A d d e n d u m

Iowa Department of Transportation
Office of Contracts

B.O.	Proposal ID	Proposal Work Type	County	Project Number	Addendum
109	78-0292-078	PCC PAVEMENT - GRADE & REPLACE	POTTAWATTAMIE	IMX-029-2(78)44--02-78	16APR109.A02

Replace plan sheets B.4, C.1, C.2, C.3, C.4, C.5, C.7, C.8, C.11, C.19, V.1 and V.4 with attached plan sheets B.4, C.1, C.2, C.3, C.4, C.5, C.7, C.8, C.11, C.19, V.1 and V.4.

AGGREGATE
FOR PAVED
SHOULDER FILLET

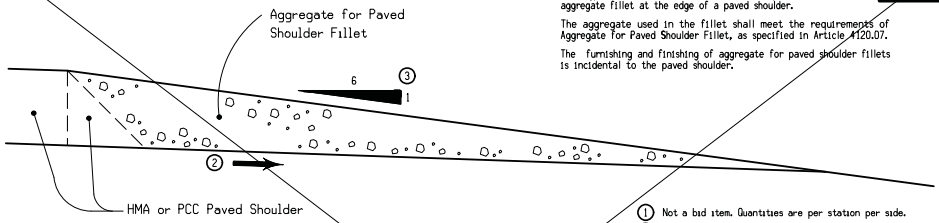
Road Design Detail 7145 deleted from Final Plans.
Earth Fill to be used in lieu of Granular Shoulder Fillet.
Top 6' of Earth Shoulder Fill is Topsoil and included in Topsoil Quantities.

DESIGN TEAM hgm	RETROFIT BARRIER RAIL DETAILS	MODIFIED STANDARD SHEET 1031T	POTTAWATTAMIE COUNTY	PROJECT NUMBER IMX-029-2(78)44--02-78	SHEET NUMBER V.1

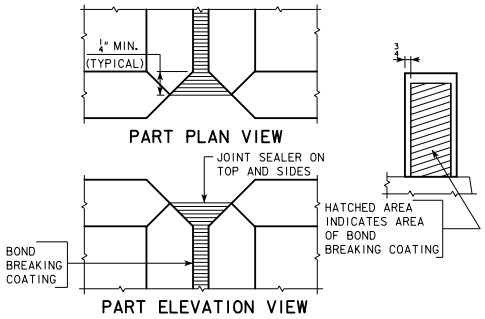
REVISED 4/4/13: REVISED SECTION AND MAINTENANCE NUMBER

I-29 OVER PONY CREEK
T 74 N R 43 W
SECTION ~~29~~ 30
LEWIS TOWNSHIP
LATITUDE: 41.18180603
LONGITUDE: -95.82368618
POTTAWATTAMIE COUNTY
MAINTENANCE NO. ~~7844 BL029 (SBL)~~ 7845. IL029 (SBL)
FHWA NO. 044560 (SBL)
